Number **1**  
 Date **APRIL 15, 1982**  
 Page **1** of **4**

Models Affected: **ADVANTAGE**      Class of Change: **MANDATORY**  
 Assembly(s) Affected: **ADV BASE ASSY**      Field Action: **INSTALL ON NEXT CALL**  
 Factory Implementation: **5-1-82**      Est. Install. Time: **0.5** Hrs.

# ADVANTAGE GROUNDING RETROFIT INSTRUCTIONS

FIGURE 1

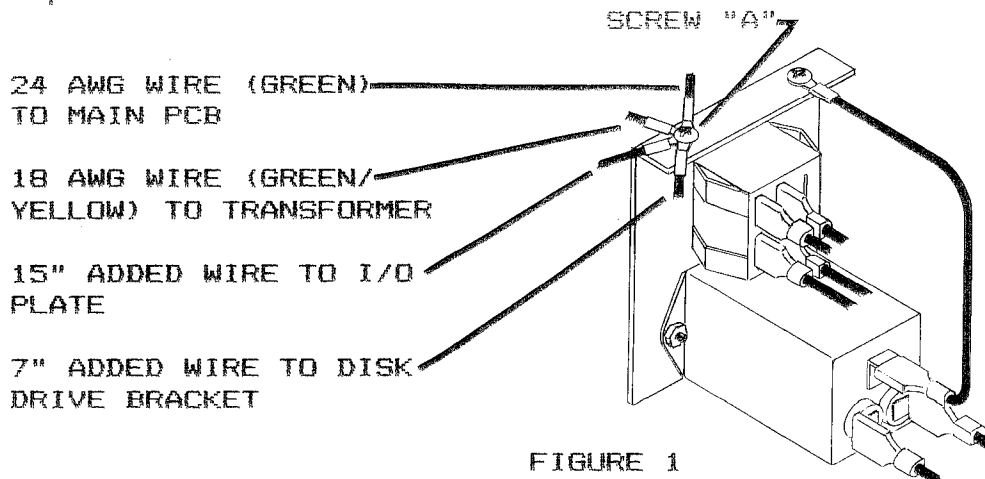
1. Disconnect the Advantage from the AC power source.
2. Remove the top cover of the Advantage as described in Section 6.5.2 of the Advantage Technical Manual (North Star P/N 00464).
3. Using Figure 1 as a reference, remove screw A on the AC power panel. (NOTE: this screw already secures two (2) wires, one solid green 24 awg wire going to the main PCB connector and one green/yellow 18 awg wire going to the power transformer).

FIGURE 2

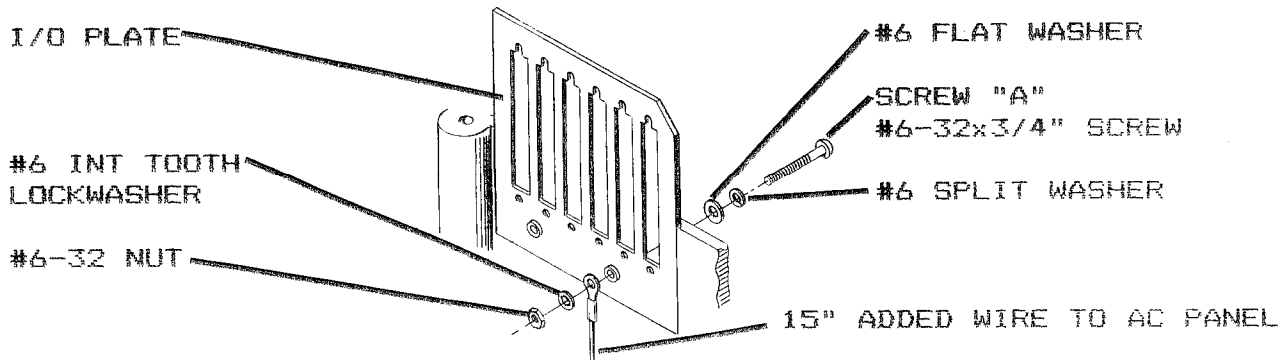
4. Attach one end of each of the two wires supplied in the kit to the screw removed in step 3 along with the two wires already attached to the screw and replace the screw on the AC power panel.
5. Using Figure 2 as a reference, remove screw A on the I/O mounting panel. Discard this screw.

FIGURE 3

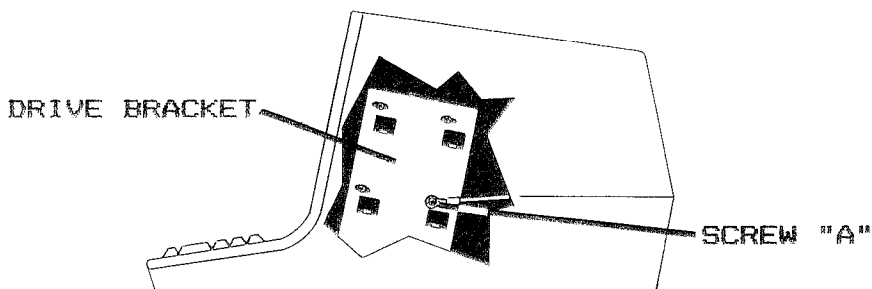
6. Using the hardware supplied in the kit, install the loose end of the 15" wire to the I/O mounting plate as shown in Figure 2.
7. Using Figure 3 as a reference, remove screw A on the disk drive mounting bracket.

8. Connect the loose end of the 7" wire to the drive mounting bracket using the screw removed in step 7.
9. Using a DVM, check to make certain that there is zero ohms between the I/O mounting panel, the disk drive bracket and the AC power panel.
10. Replace the Advantage top cover as described in Section 6.5.2 of the Advantage Technical Manual.

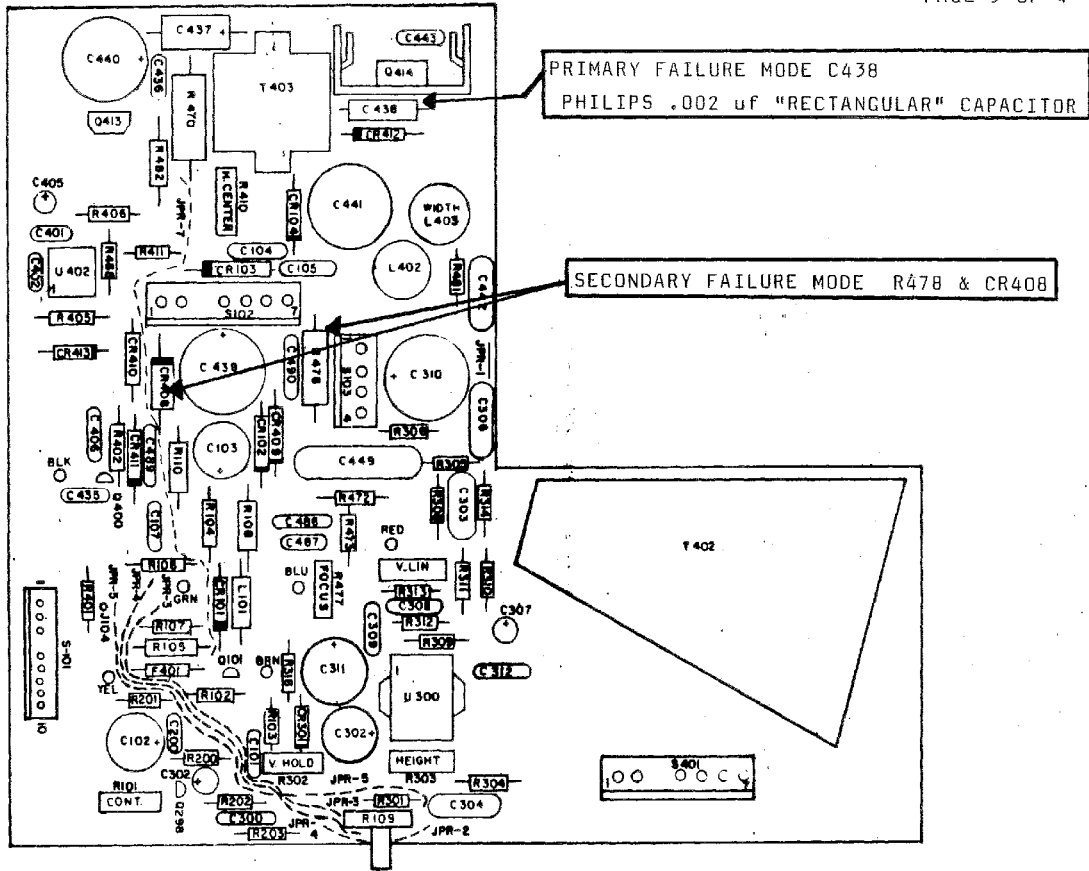
The primary failure mode is a failure of capacitor C438 on the Elston supplied video PCB. See attached assembly drawing (Figure 1) for parts location. NOTE: ONLY PCBs CONTAINING A YELLOW .022 Mf RECTANGULAR CAPACITOR MADE BY PHILIPS ARE PRONE TO THIS FAILURE. Boards containing an axial lead tubular .022 Mf capacitor are okay.

Once capacitor C438 fails, excessive current will flow through resistor R478 and diode CR408 causing failure of those components, discoloring and possible burning of the PCB material.

You may receive replacement capacitors free of charge by calling Barry Bearden at North Star. Additionally, North Star will issue a \$20.00 credit per ADVANTAGE to any Authorized Dealer, Distributor or OEM performing this modification. To receive this credit please indicate the serial number(s) of unit(s) being modified when you call. A credit memo will be issued upon verification of the serial number. Replacement of this capacitor by competent service personnel will not void the North Star warranty. NOTE: REPLACEMENT OF THE CAPACITOR SHOULD NOT EFFECT THE VIDEO ALIGNMENT OF THE ADVANTAGE.

FIGURE 2

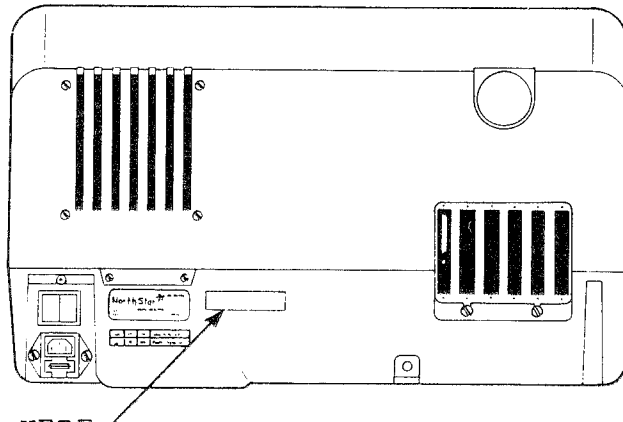
Apply self adhesive FCC sticker (North Star Part Number 02292A) to the rear of all ADVANTAGE computer systems currently in inventory as indicated in Figure 2.

FIGURE 2

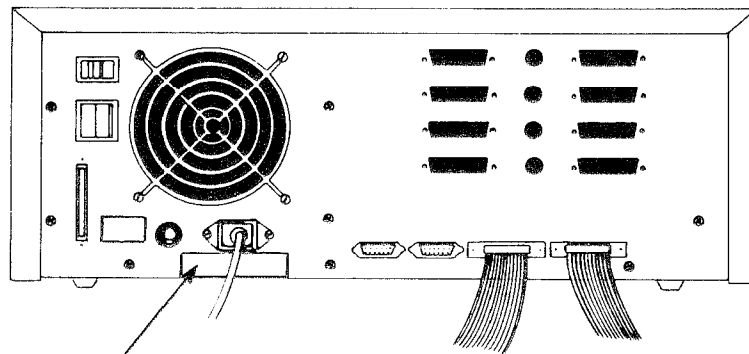
Apply self adhesive FCC sticker (North Star Part Number 02292A) to the rear of all HORIZON computer systems currently in inventory as indicated in Figure 2.

FIGURE 2

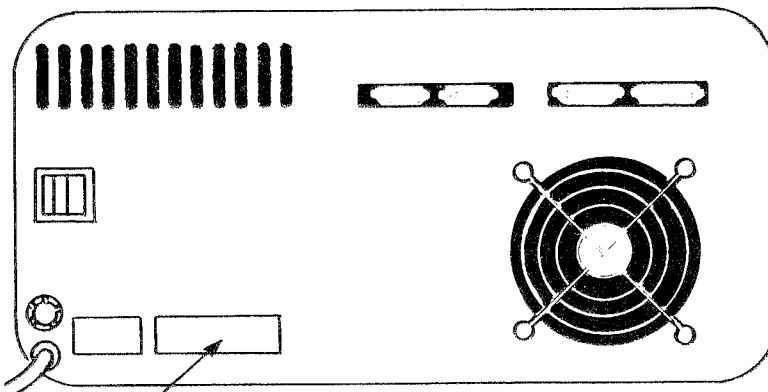
Apply self adhesive FCC sticker (North Star Part Number 02292A) to the rear of all HD-18 hard disk systems currently in inventory as indicated in Figure 2.

FIGURE 2

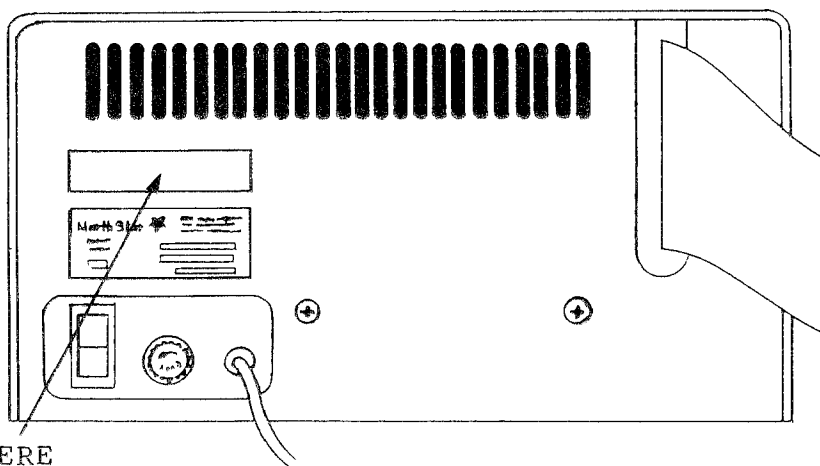
Apply self adhesive FCC sticker (North Star Part Number 02292A) to the rear of all TAPE BACK-UP SYSTEMS currently in inventory as indicated in Figure 2.

FIGURE 1

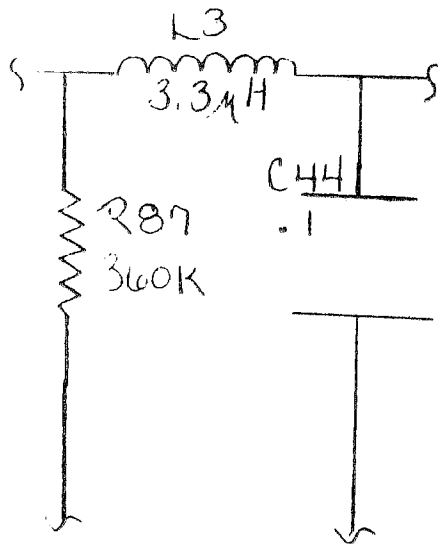
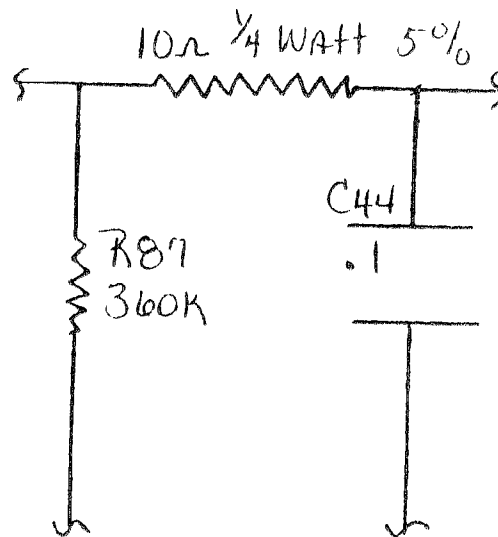
The modification is accomplished by removing L3 (3.3 micro henry coil) located at IC 1A on the main PCB of the ADVANTAGE and replacing it with a 10 ohm 1/4 watt resistor designated R108.

4. Using Figure 1 as a reference, desolder L3 (3.3 micro henry inductor) at location IC 1A on the main PC Board.
5. Remove the excess solder from solder pads and holes.

6. Install resistor (North Star P/N 61053) 10 ohm, 1/4 watt, 5% in place of L3.
7. Replace ADVANTAGE top cover as outlined in Section 7.3.1 of the ADVANTAGE Technical Manual.
